Technical Review

Assessment of the Environment Agency's Response to Recommendations from a Review (September 2024) of Horncastle Reservoir Asset Performance during Storm Babet, and the Associated Flooding at Horncastle, Lincolnshire.

06/02/2025

80863.03R2

Figure showing location of hydrometric gauges within the Bain catchment
Source: AECOM Model Report (Appendix 4, EA*4, 2024)

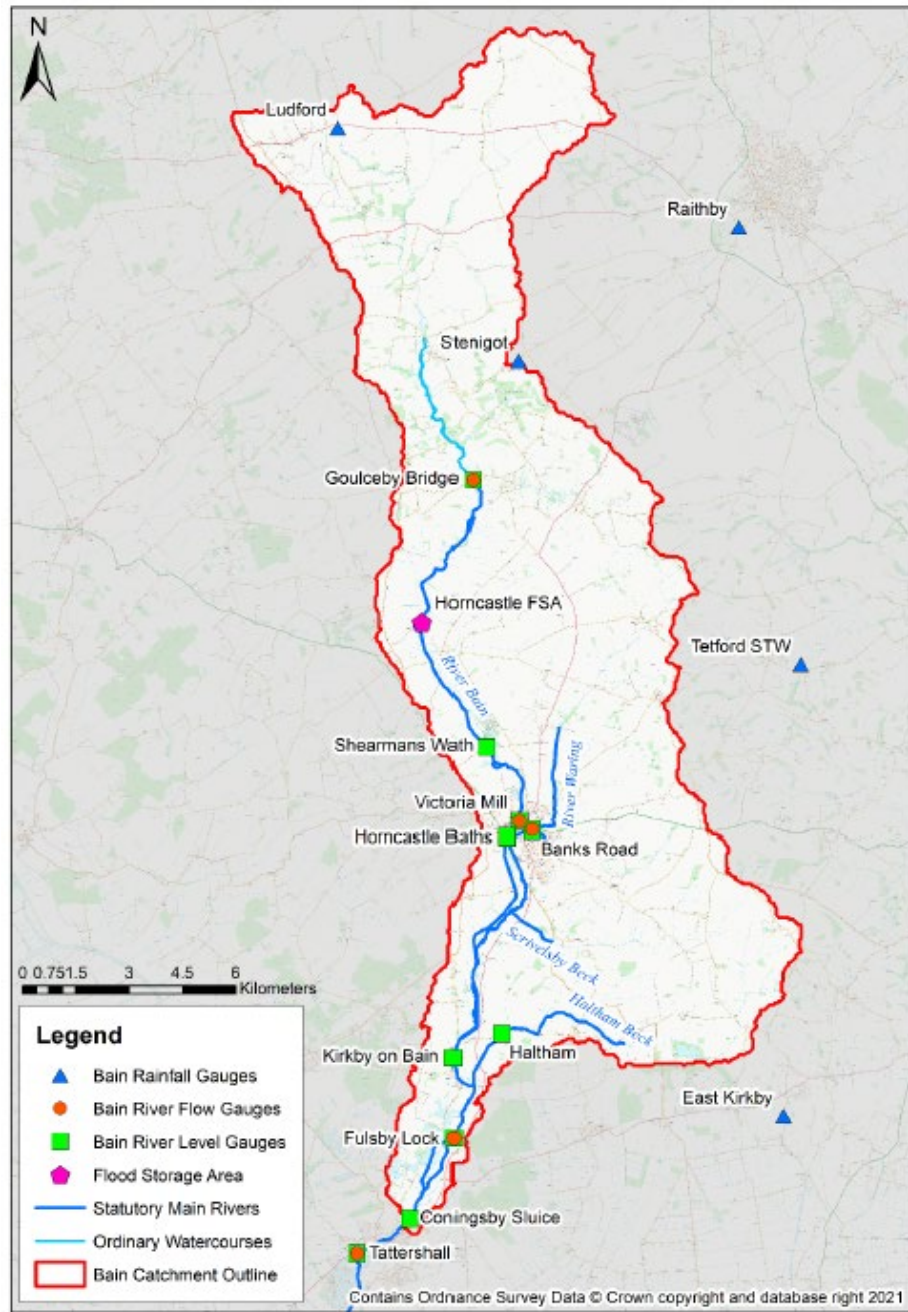
The EA provided a detailed spreadsheet containing observed levels and flows, including the intermediate gauging station at Shearmans Wath between HFSR and Victoria Mill GS. No further information is required unless further modelling is to be undertaken.

Figure showing cumulative rainfall totals for selected catchments

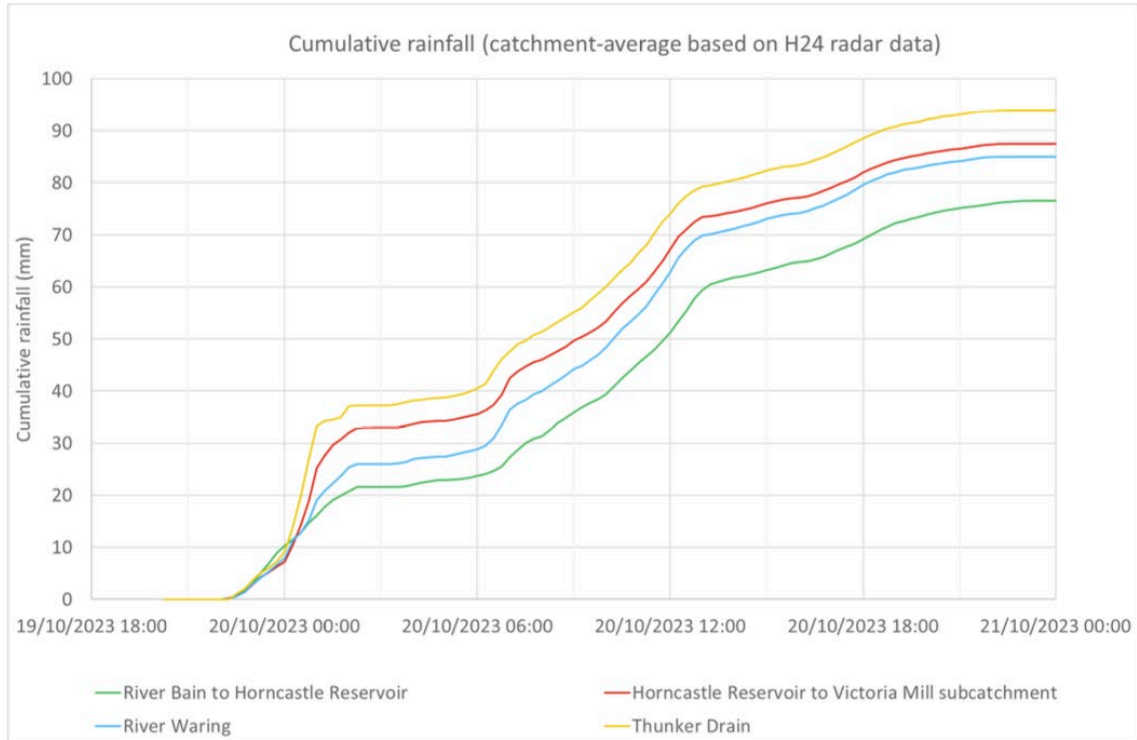
Rainfall is in the order of 1 in 25 to 1 in 50 Annual Exceedance. Both River flow and stage at Victoria Mill are between a 1:100 and 1:200 Annual Exceedance. The EA refer to the Waring being a 1:1000 event, but the runoff from the Hemingby and West Ashton tributaries seems to have been even greater, even though the rainfall over these catchments seems not to have been much more than that over the Bain upstream of the FSR (see below, from Storm Babet October 2023. Horncastle Asset Operation Failure Impact Assessment).

Although it may be the case that significant variance can occur between rainfall and river flow annual exceedance probability, it is the central puzzle of the Babet flood in Horncastle and it warrants further assessment in any future work on assessing the flood risk to Horncastle.

It is recommended that the model outcome for the Babet storm is compared with the 2020 model results for the 1% storm, which “generally reported a good fit to observed data as all sites on the River Bain between the FSR and Horncastle” according to the Bain 2020 model report.
